PRODUCT CHANGE NOTIFICATION

Bourns® PEC11J Series 12 mm SMD Long Life Encoder

Solderability Change

SC2620

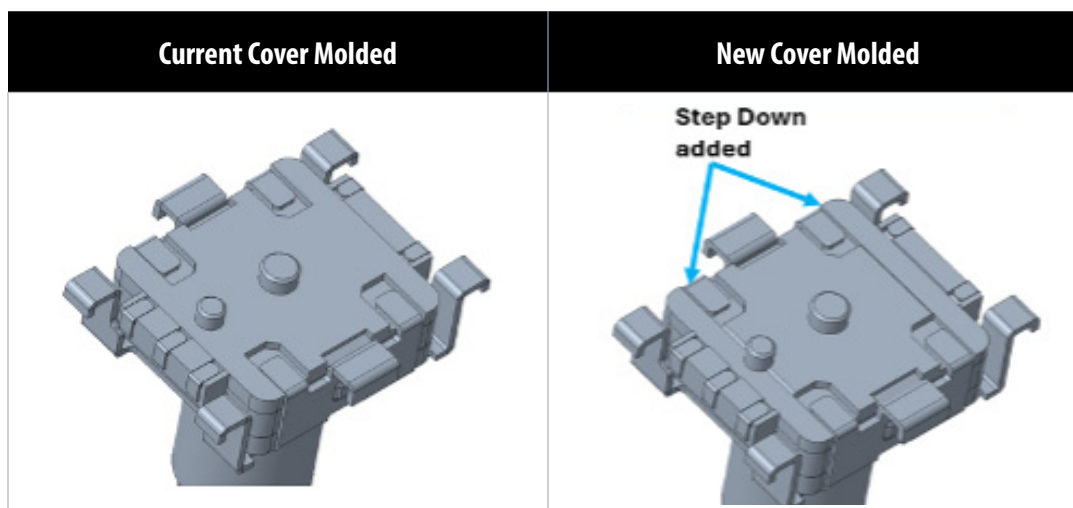
Riverside, California – June 15, 2026 – Effective June 30, 2026, Bourns will modify the molded cover of the PEC11J Series 12 mm SMD Long Life Encoder to improve solder process reliability. The modification adds a step-down feature to the sides of the cover that prevents solder from flowing to the terminals during reflow when the bracket is installed.
